Supersedes:
E8356A-02C

E8356A PNA Series RF Network Analyzers

ADMINISTRATIVE INFORMATION

November 15, 2007

Figure 1

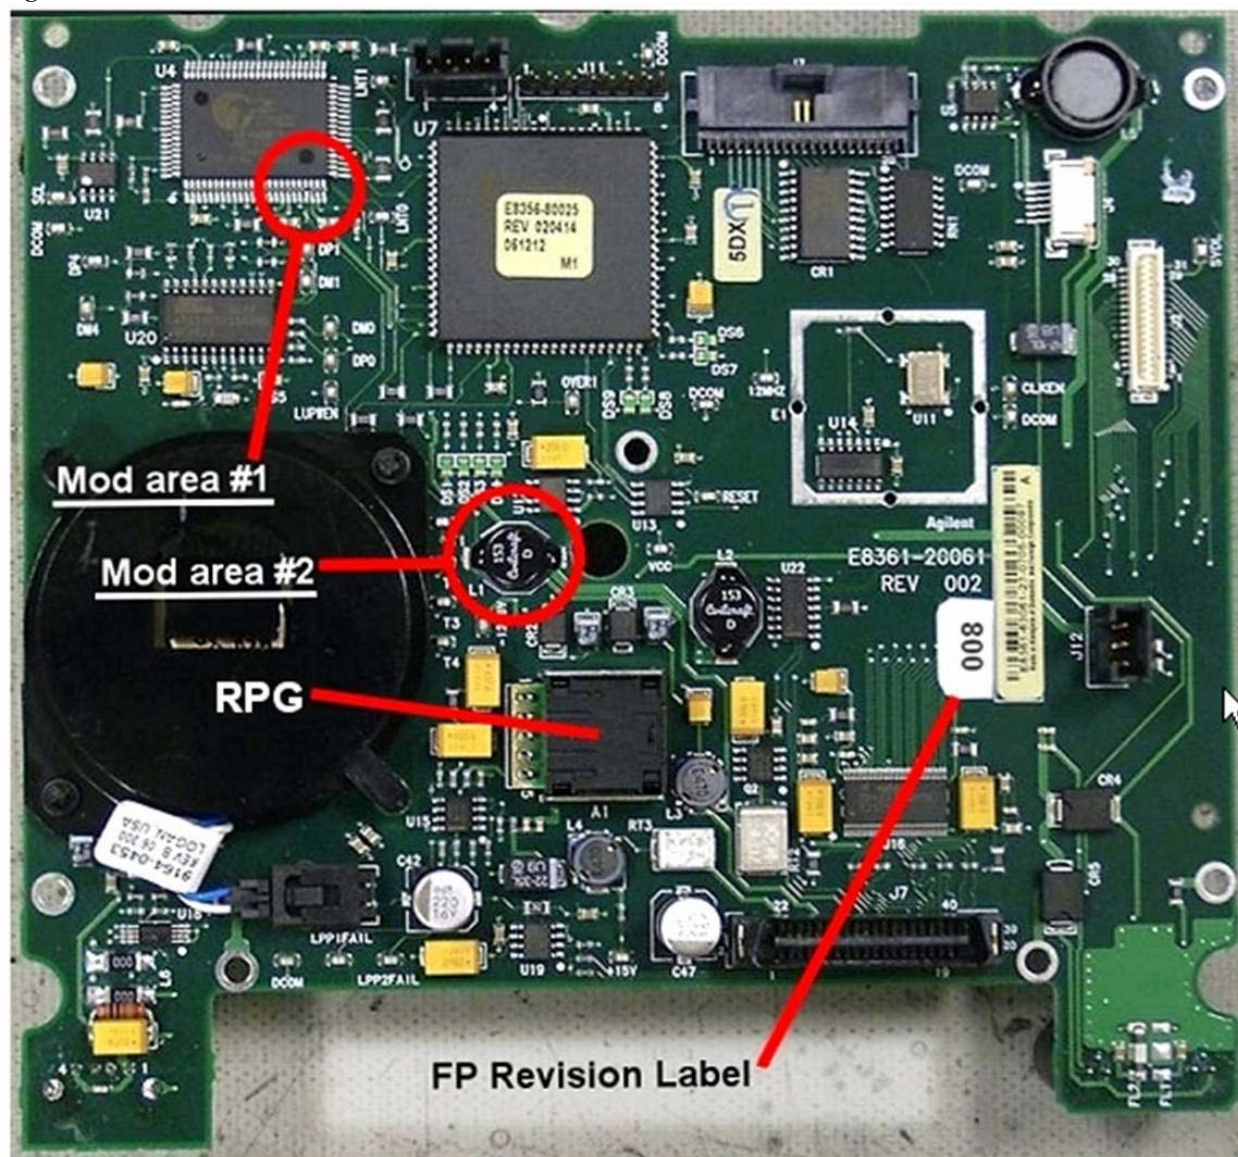
Refer to Figure 1 for the two modification areas to be addressed. Note that while this picture happens to show the FPI board completely removed from the front frame assembly, this is not necessary to perform the required modifications.

- Modification #1 consists of shorting two pins of U4 together with a small amount of solder.
- Modification #2 consist of removing L1.

Unsolder and completely remove the black surface mount inductor L1 from the front panel assembly board. This is no longer needed and can be discarded.

Figure 2

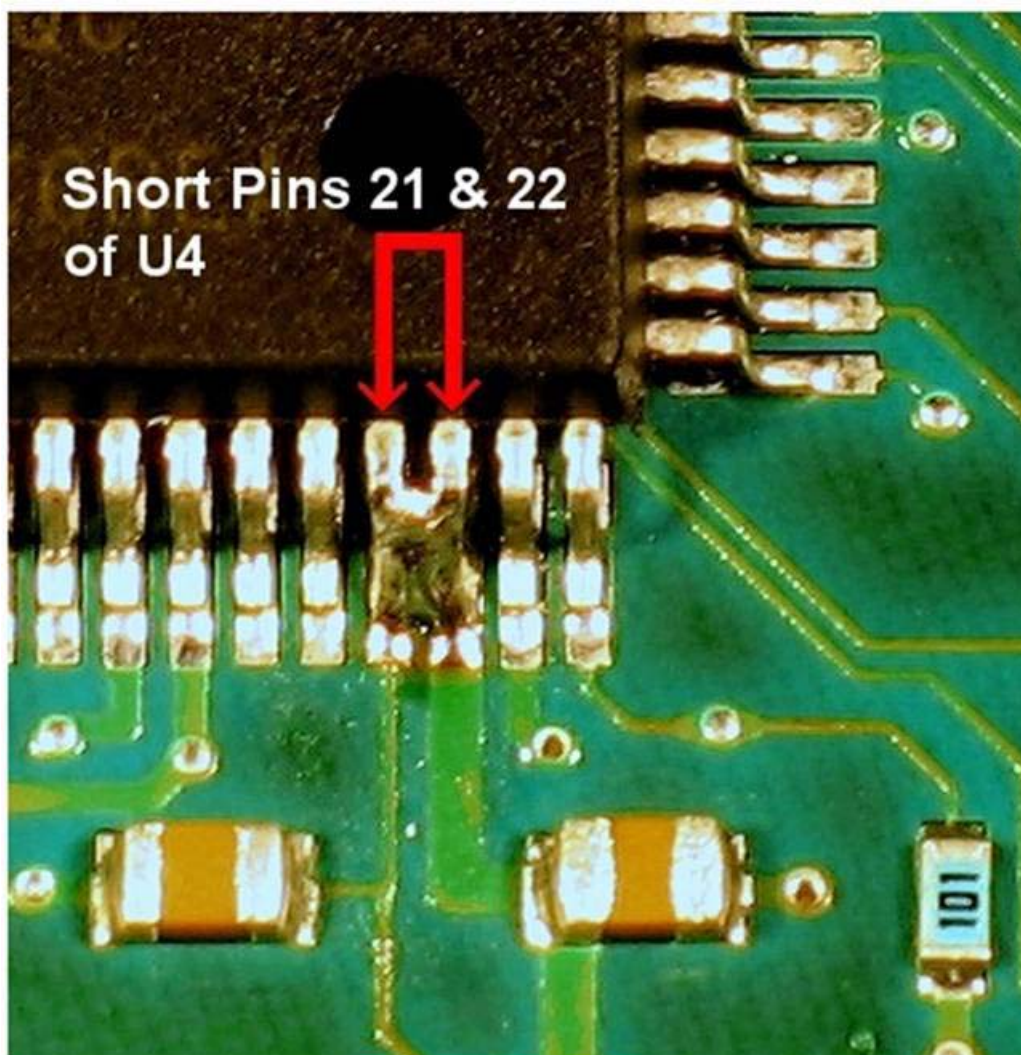
Modification #1

Carefully solder pins 21 and 22 together on U4. Refer to Figure 2 for the exact location. Use care so that no other pins are shorted. Use of a very fine tip soldering iron is recommended and a large work-task magnifying glass is very helpful.
